City of Portland, Maine - Building or Use Permit Application

Location of Construction: <i>units #3 & 4 Meadow Woods</i>	Owner Name: Rodway Charles	Owner Address: 70 Jordan Shore Dr Poland, Me 04274	Phone: 207-878-2241
--	-------------------------------	---	------------------------

**CITY OF PORTLAND, ME
BOCA 1999 Plan Review Record
One and Two Family Dwelling**

Building Location: UNITS 3 & 4 Leisure Lane - Meadow Woods
~~42 Harrison St~~ CBL: 336-L-008

SECTION 1014.6 TREADS & RISERS

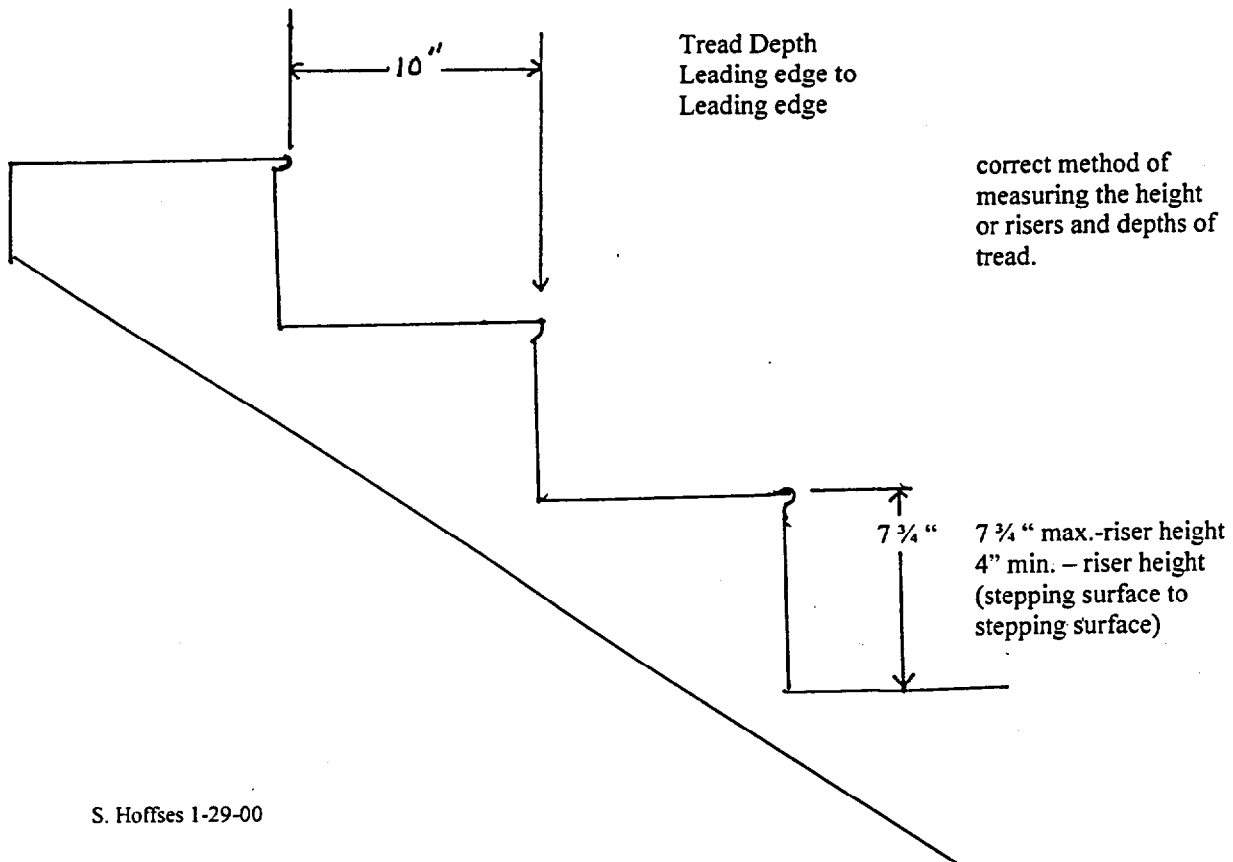
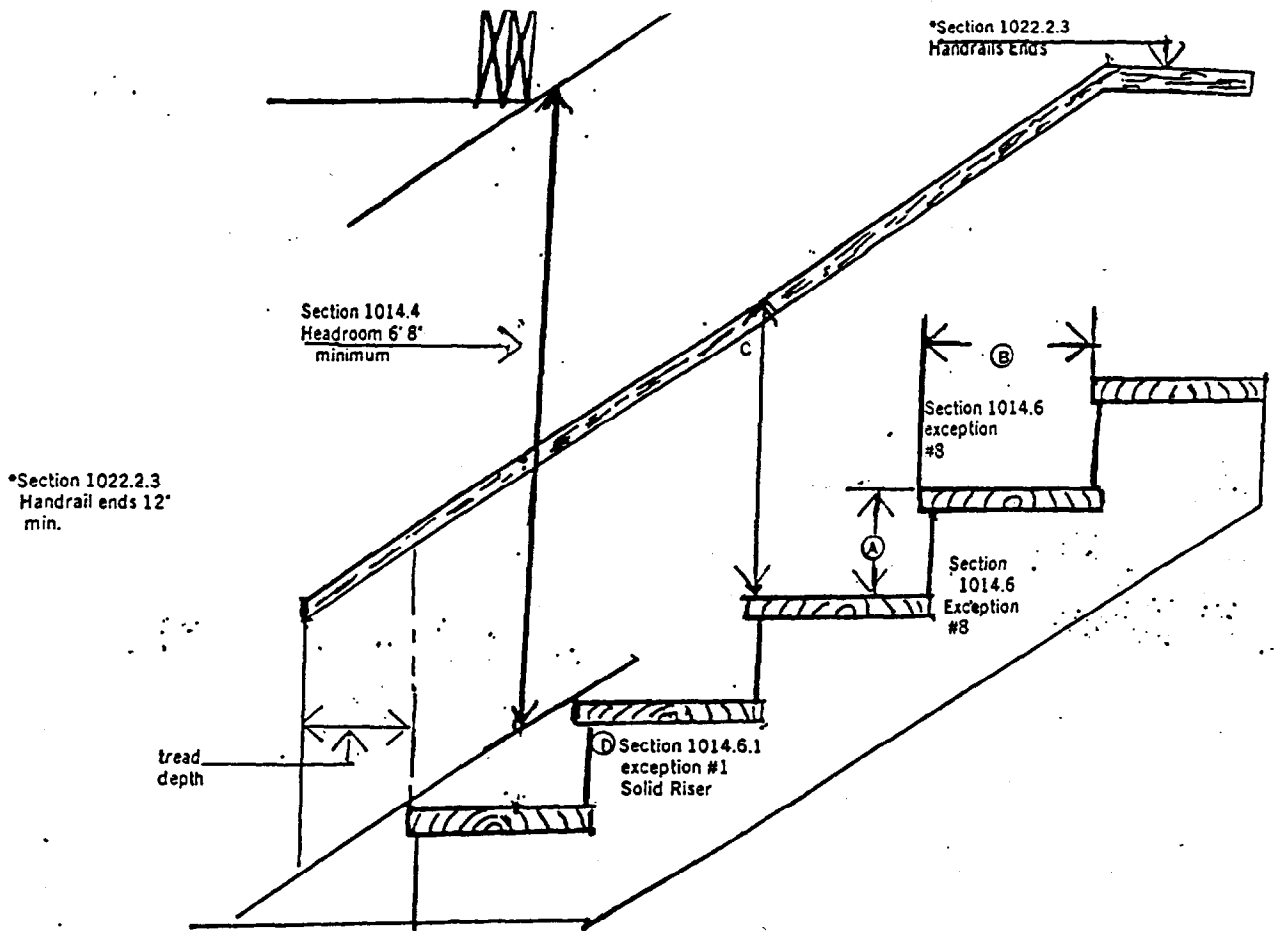
7.	Guardrails and handrails shall comply with section 1021.0 & 1022.0	1021.0 1022.0
8.	Stair construction shall comply with section 1014.0 (See attachment)	1014.0

EXCEPTION: NO. 8 – In occupancies in use group R-3, within dwelling units in occupancies Use Group R-2 and in occupancies in Use Group U which are accessory to an occupancy in Use Group R-3. The maximum riser height shall be 7 ¾ inches (197mm) and the minimum tread depth shall be 10 inches (254mm). A nosing not less than ¾ inches but not more than 1 ¼ inches (32mm) shall be provided on stairways with solid risers where the depth is less than 11 inches (279mm).
